PUBLIC INTEREST REVIEW FOR GROUNDWATER APPLICATIONS

TO: Water Rights Section Date 10/10/2019  
 FROM: Groundwater Section Phillip I. Marcy  
 SUBJECT: Application G- 17592 Supersedes review of April 15, 2019  
 Reviewer's Name  
 Date of Review(s)

**A. GENERAL INFORMATION:** Applicant's Name: Golden Rule Farms, Inc. County: Harney

### Water-Level Trends in Nearby Wells

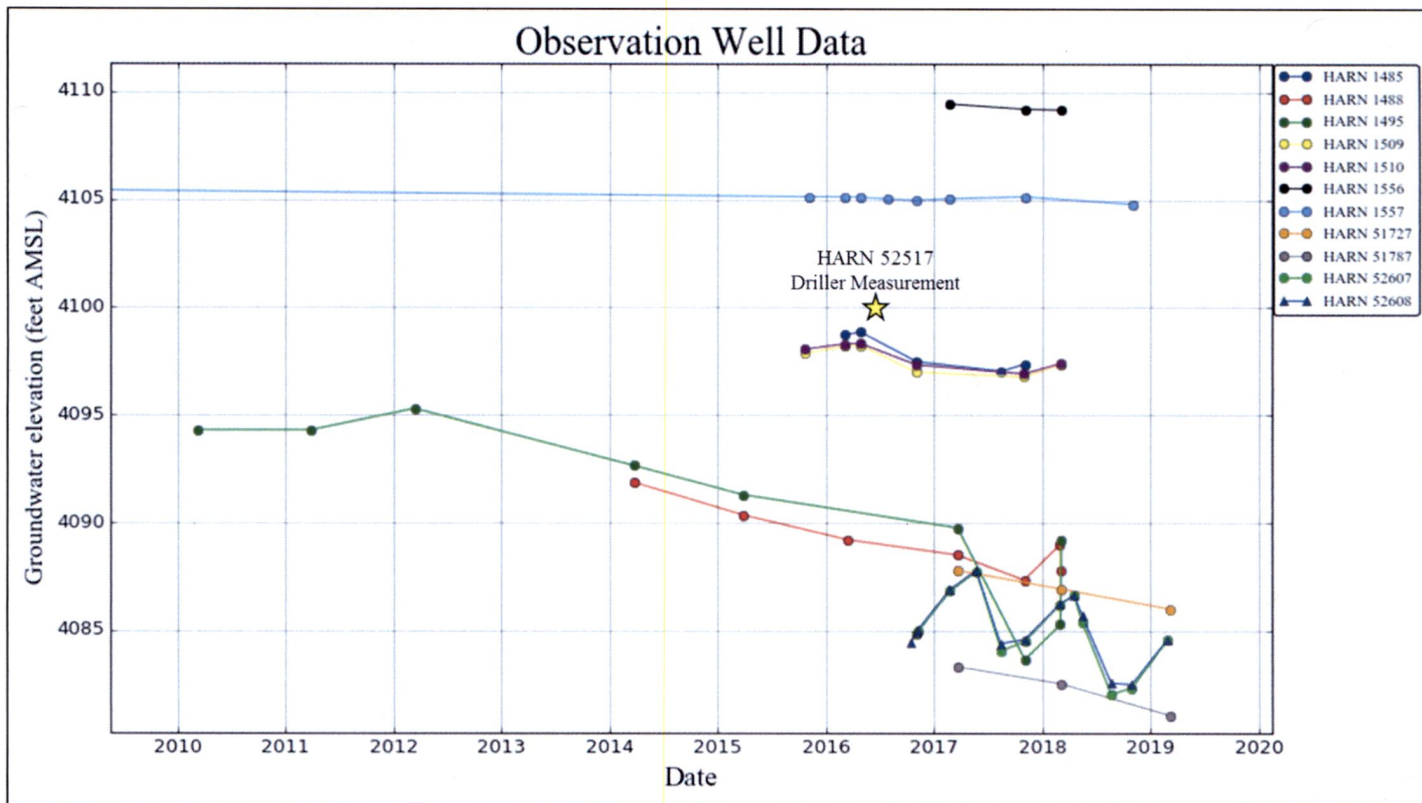
The hydrograph for wells in the area surrounding the proposed POA locations under G-17592 (see attached) displays general declines in groundwater elevations (locations on attached map). The steepest declines shown here are observed in the Virginia Valley immediately to the north. Declines are less severe in wells within the same WAB as the proposed POA wells, but are noteworthy because there are currently no active groundwater rights within its boundaries. This suggests, for one, that groundwater pumping has had impacts across basin boundaries and for two, that significantly increasing the burden of pumping on the aquifer system locally would likely lead to steeper declines within this WAB, and exacerbate further the declines observed in the Virginia Valley.

The hydrograph for wells in the area surrounding the proposed POA locations under G-17592 displays general declines in groundwater elevations (locations on map above). The steepest declines here are observed in the Virginia Valley to the north, where significant quantities of groundwater have been allocated. Declines are less severe in wells within the same WAB as the proposed POA wells (HARN 1485, HARN 1509, HARN 1510), but are noteworthy because there are currently no active groundwater rights within its boundaries.
